CITY OF ALBUQUERQUE

July 18, 2018

RE: **McMahon Carwash**
McMahon and Fineland NW
Grading Plan Stamp Date: 6/20/18
Drainage Plan Stamp Date: 6/20/18
Hydrology File: A11D016A

Based on the submittal received 7/10/18, the Grading Plan and Drainage Report cannot be approved for until the following are corrected:

ENGINEER'S SEAL	McMAHON CARWASH	DRAWN BY WCWJ
		DATE 6-01-18
		218114-LAYOUT-5-24-18
		SHEET # —
		JOB # 218114
6/20/18	 <i>Rio Grande Engineering</i> 1606 CENTRAL AVENUE SE SUITE 201 ALBUQUERQUE, NM 87106 (505) 872-0999	
DAVID SOULE P.E. #14522

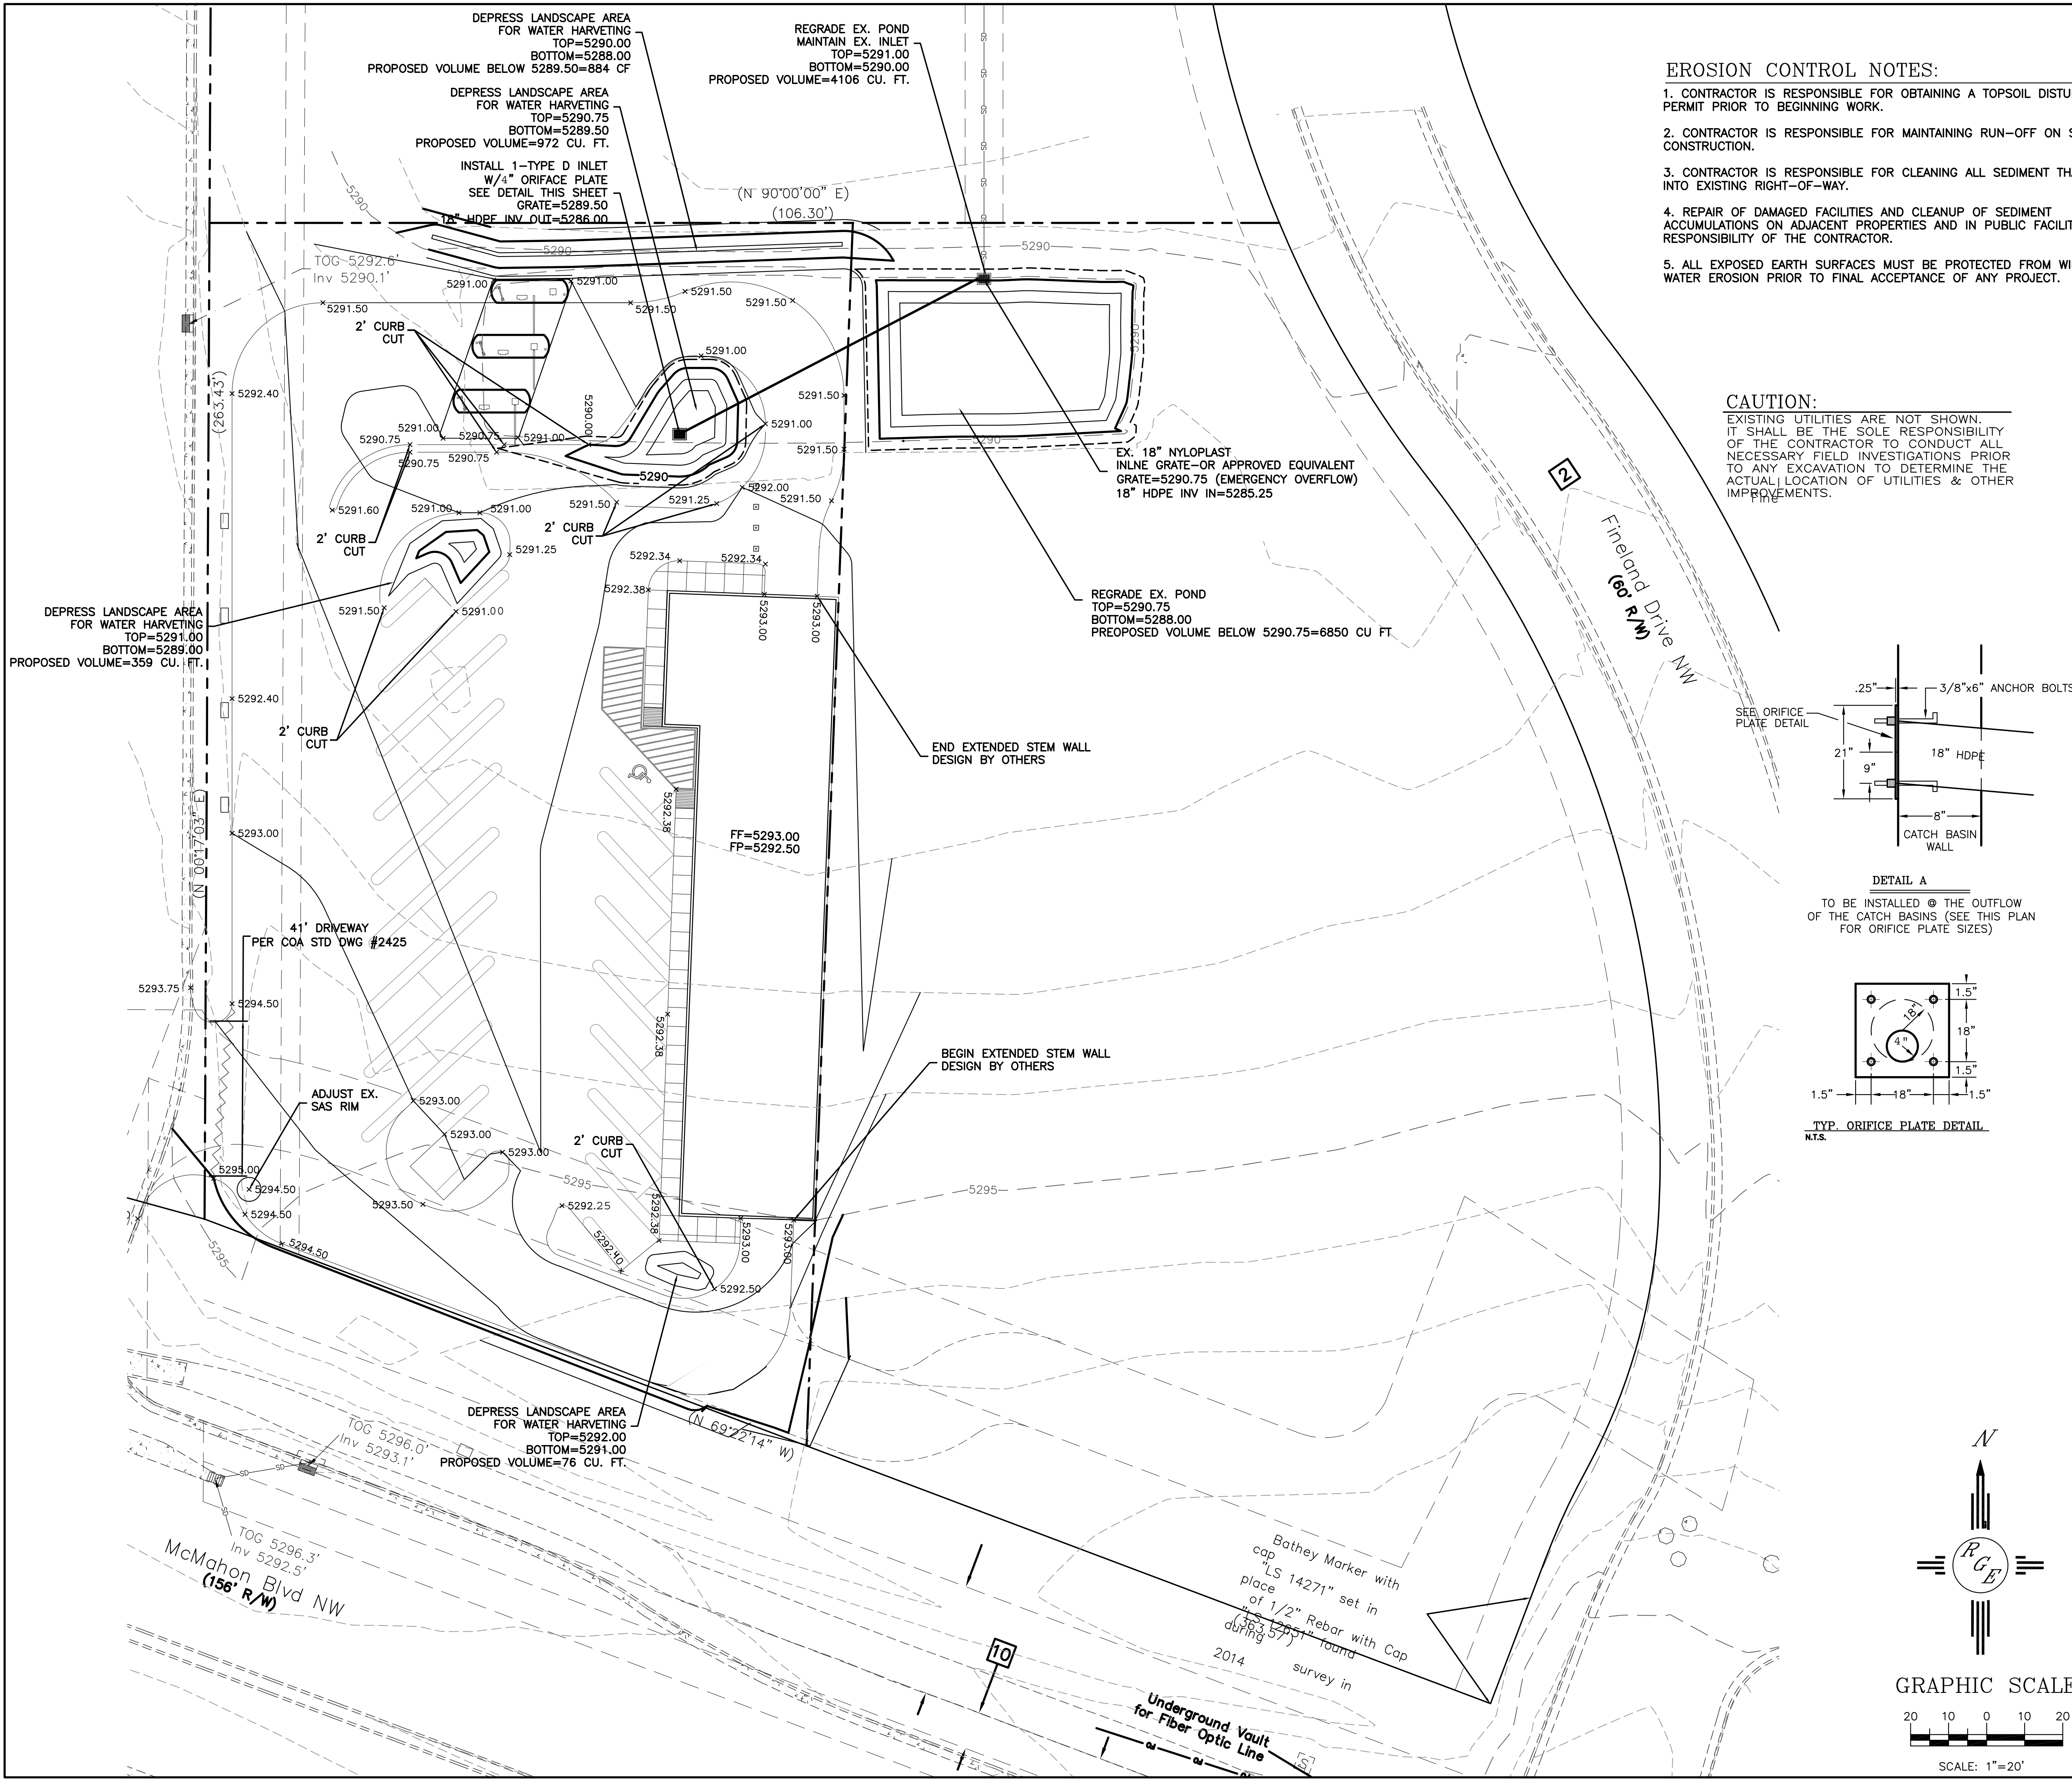
1. The first flush retention areas need to be clarified. The 4 small ponds in West Basin do not adequately capture the required volume. The north pond is higher than the parking lot and nothing seems to drain to it. The center pond has the grate elevation set at the bottom of the pond, so no dead storage is provided. The area draining to the 2 south ponds needs to be quantified, and the ponds sized to retain this first flush volume.

2. Provide minor contour labels and define spot elevations (top of curb, flowline, etc...). The spot elevations don't appear to agree with the proposed contours and it is difficult to see where the emergency overflows will go if the orifice plate clogs.

3. The elevations used in the volume calculations and orifice plate sizing (appendix B) do not match those on the grading plan. Please correct and show the max water surface elevation on the grading plan.
